**RE: HOMESTEAD FILING 2 – PRELIMINARY ACCEPTANCE PUNCHLIST FOR FULL SPECTRUM DETENTION POND 1**

**RE: HOMESTEAD FILING 2 – VOLUME CERTIFICATION LETTER FOR FULL SPECTRUM DETENTION POND 1**

**RE: HOMESTEAD FILING 2 – PRELIMINARY ACCEPTANCE PUNCHLIST FOR NORTH SAND FILTER BASIN**

**RE: HOMESTEAD FILING 2 – VOLUME CERTIFICATION LETTER FOR NORTH SAND FILTER BASIN**

Figure 9-38. Riprap erosion protection at circular conduit outlet (valid for  $Q/D^{2.5} \leq 6.0$ )

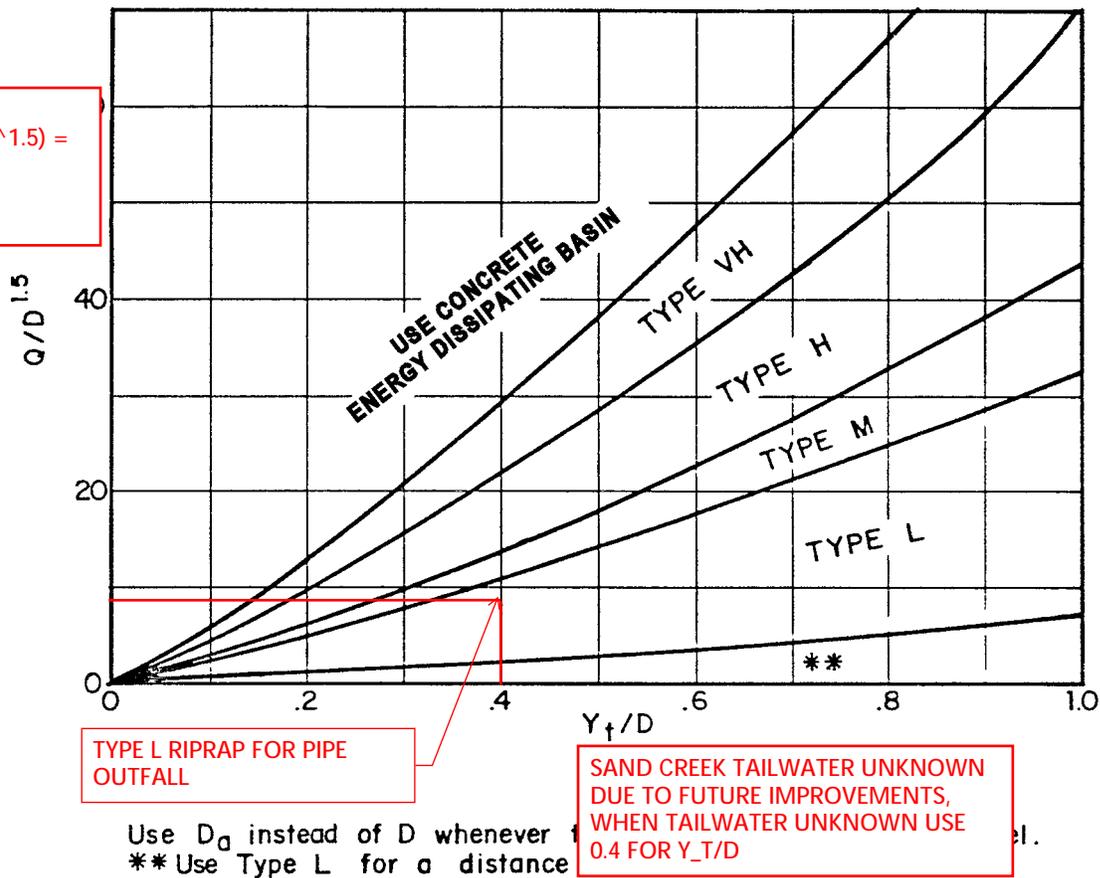
1. Micro screen installed with V-wire bars are horizontal and not vertical
2. Pond outfall not installed per plans. Plunge pool approved, 8' x 30' riprap pad installed. Discuss need for concrete cut-off wall
3. Shown plain riprap around forebay, instead of soil riprap
4. Restrictor Plate Height
5. Flat portion of Section A-A (spillway) is installed at less than 20 ft wide.

Pond Outfall

The pond outfall was constructed with an 8' x 30' Type L riprap pad. The riprap pad provides the necessary energy dissipation for the pond outfall. See attached riprap sizing for verification. This as-built condition is temporary, as the outfall will be modified to discharge onto a grouted boulder drop-structure with the Sand Creek Channel Improvements. Therefore, I recommend that the riprap pad as constructed be accepted as the Pond 1 outfall erosion protection. A concrete cut-off wall is not necessary in our opinion. Any undermining should be filled with Type L Riprap, should it occur. We believe the observed undermining was a result of incomplete riprap placement.

Basin ID: **FSD Pond 1 - As-Built Condition**

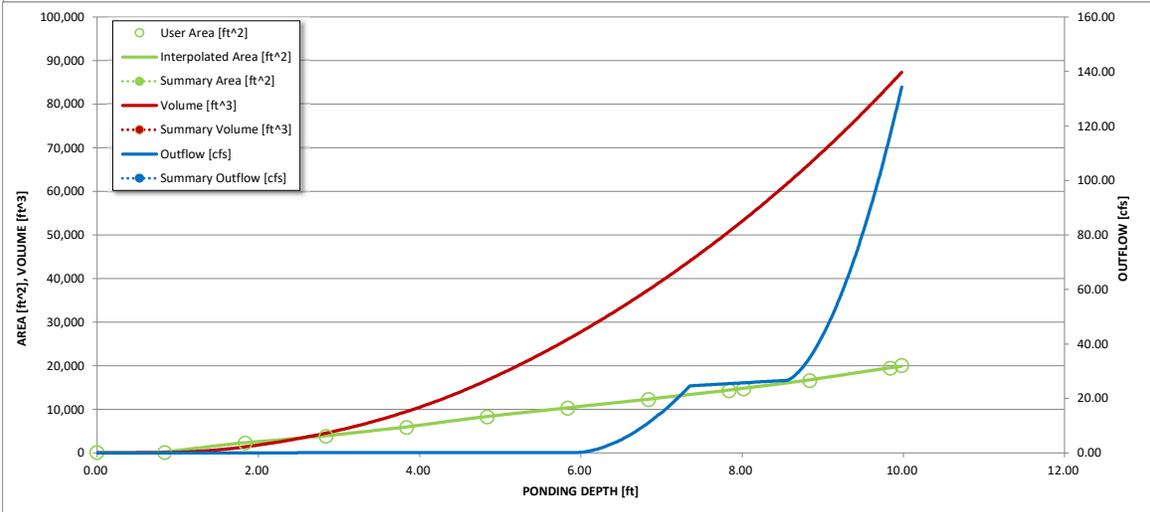
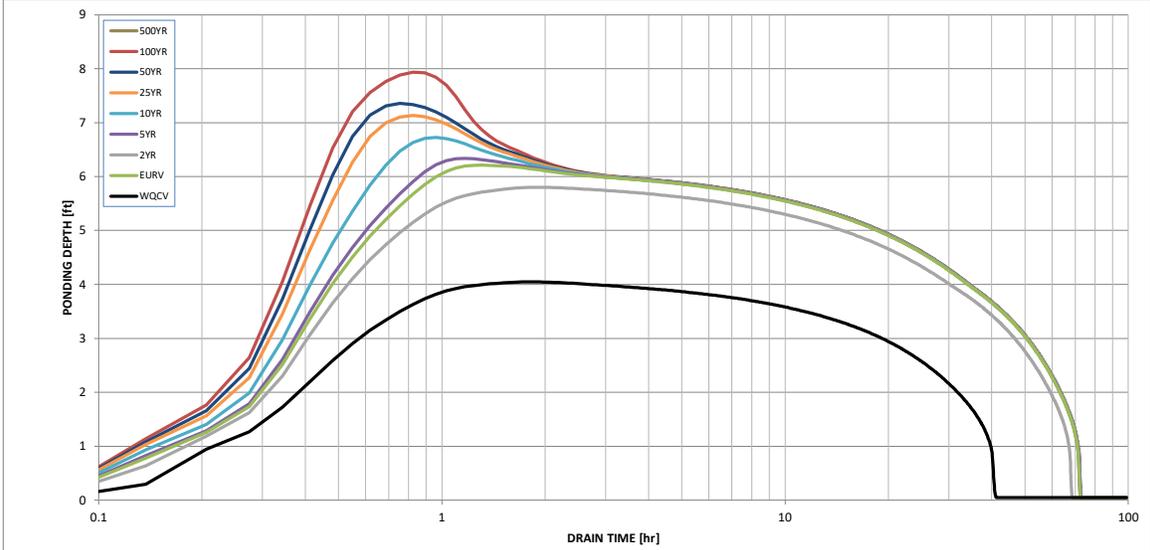
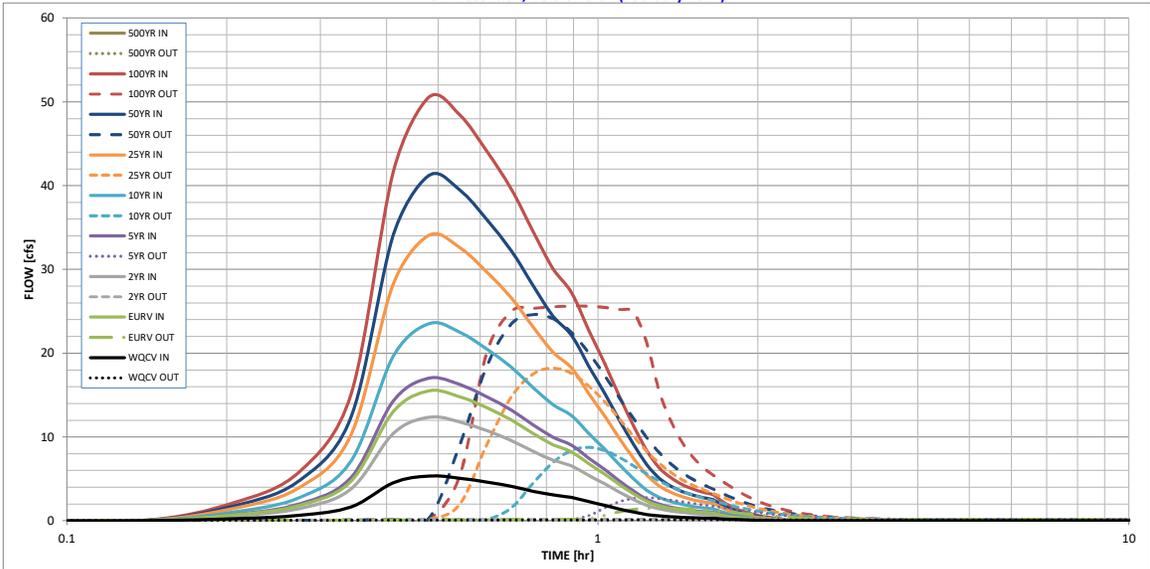
Restrictor Plate Height

### Spillway Width

The approved construction plans called out a restrictor plate height of 21.75" above the outfall pipe invert, however the UD-Detention workbook included in the approved FDR specified a height of 13.3". The plate was installed at 14" above the as-built invert, according to surveyed data. The as-built plans and as-built UD-Detention workbook reflect this as-built condition.

The spillway was proposed at 20' in the approved construction documents. However, it was constructed 16' wide. The UD-Detention 3.07 spreadsheet for Pond 1 has been updated with the 16' spillway width and confirms the spillway will pass the undetained 100-year flow with 1.0' freeboard. Therefore, I recommend the 16' spillway remain as is.

8.02 (cannot input value less than 8.55 due to workbook formulas. Causes error, will not accept lesser value.)
